2.8 Revised Scheme

CAMDEN LOCK VILLAGE
 drawing title / location
 Upper Ground Floor Layout - NMA

Stanley Sidings / AHMM / 14045 / R015 / Hawley Wharf Masterplan / July 2015

2.16 Revised Scheme

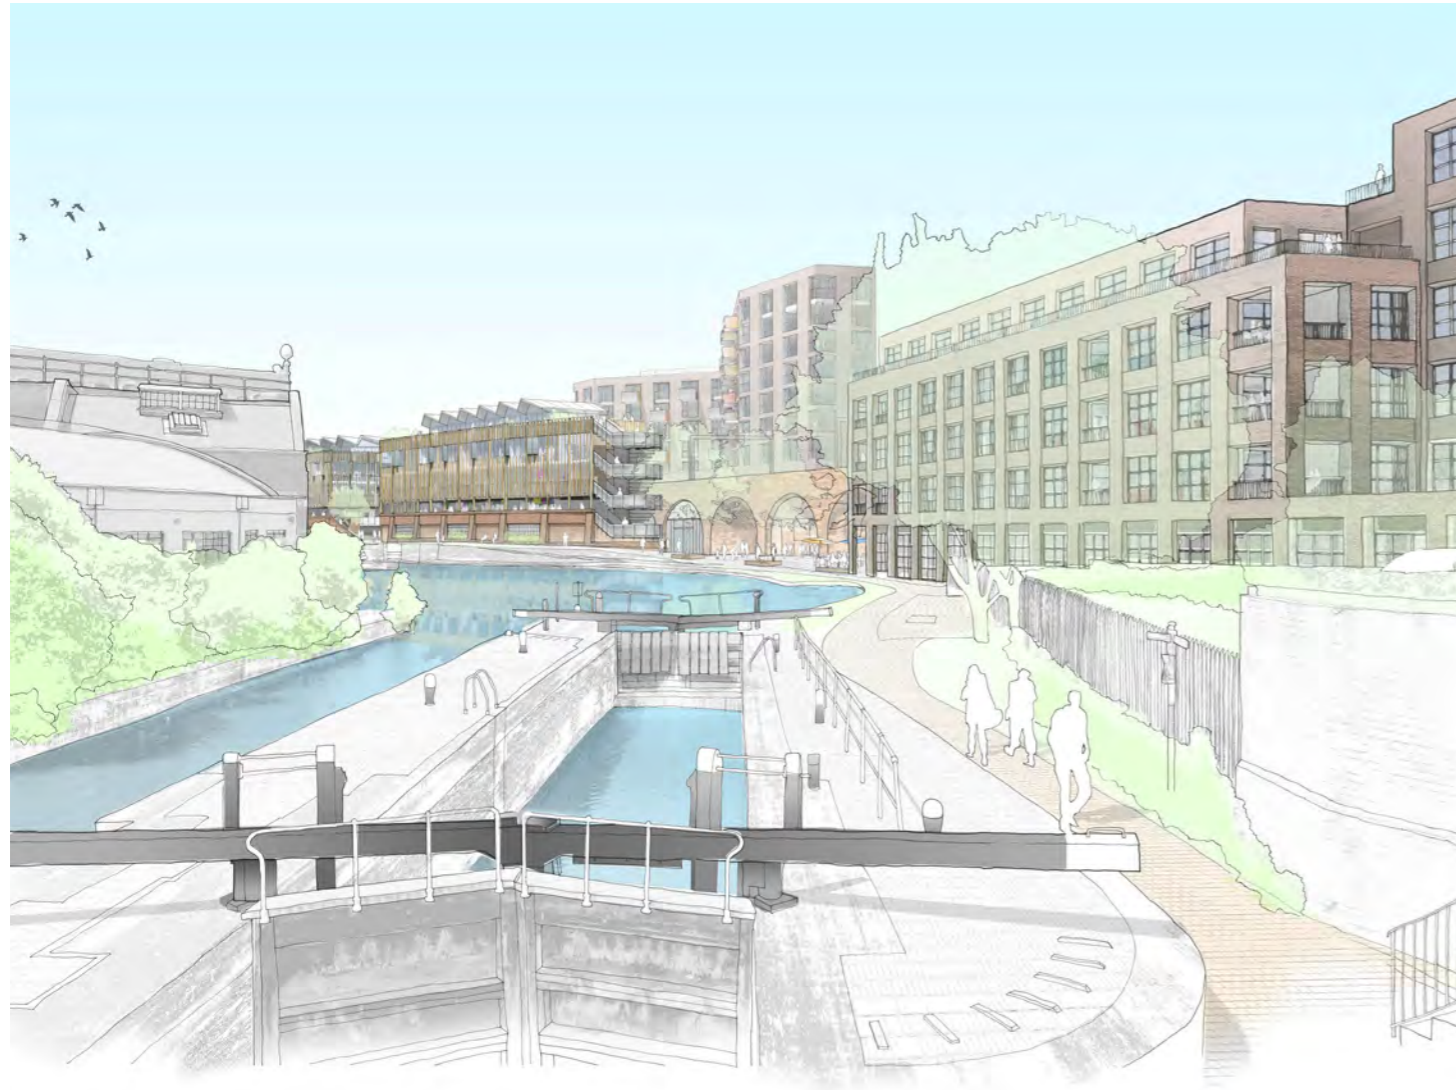
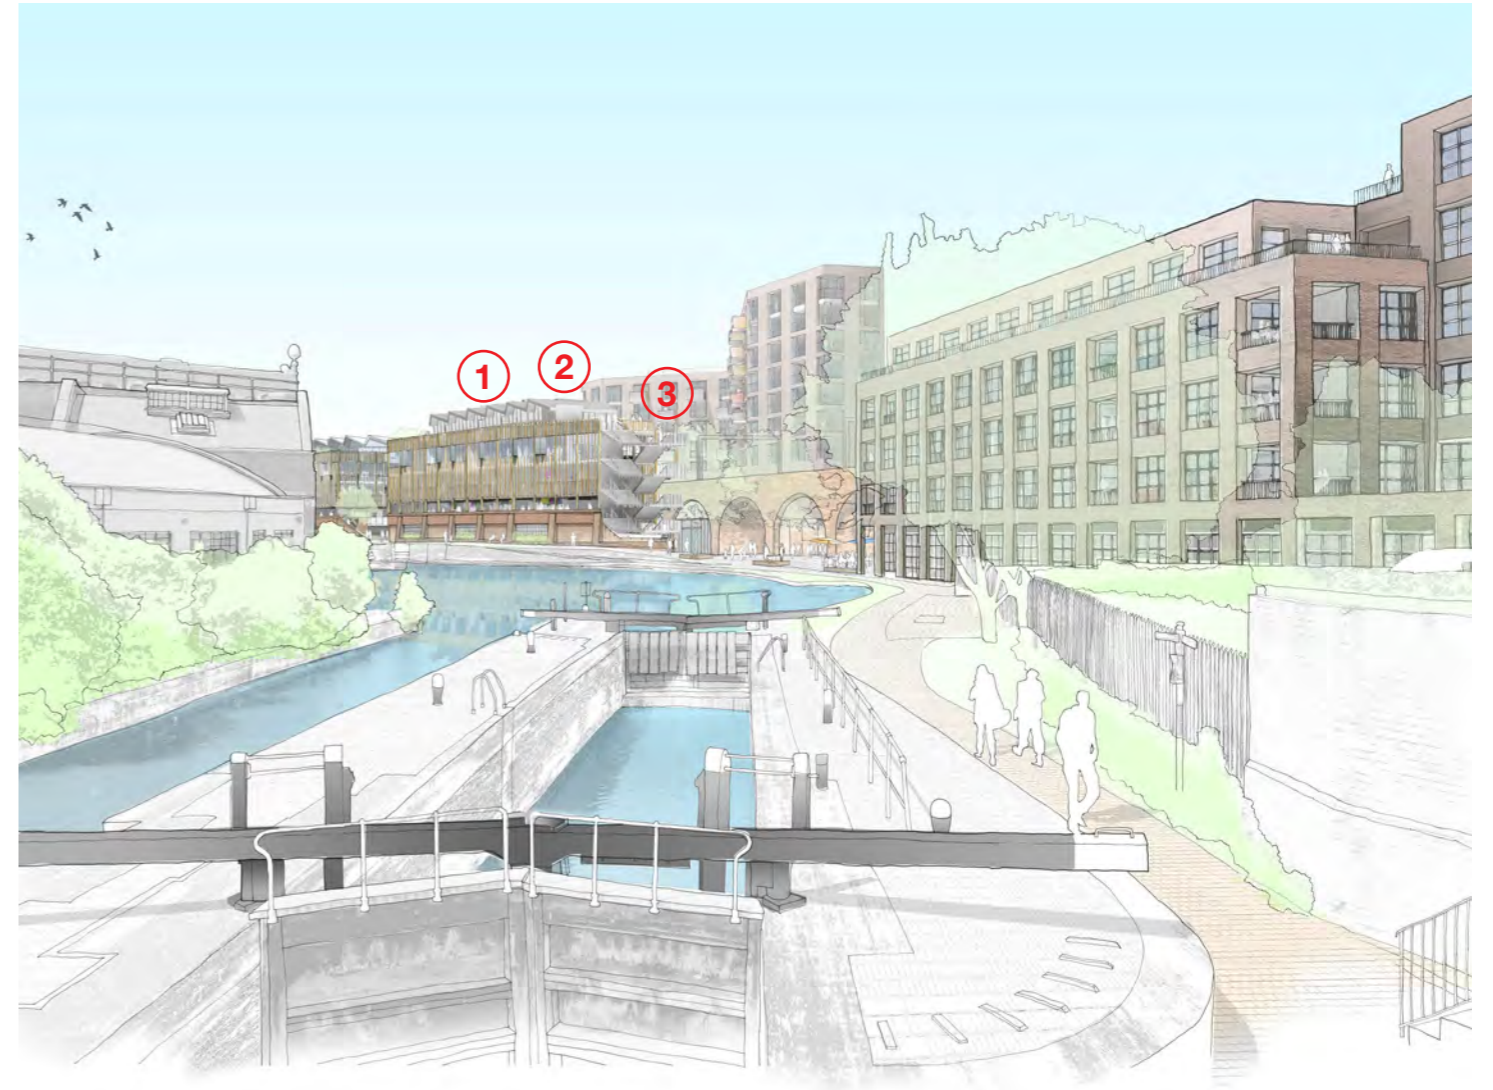
- ① Updated Rooftop Plant
- ② Lift overruns with required access as a result of detailed design.
- ② Stair re-configured as part of detailed design to ensure compliance with fire escape and accessibility requirements.
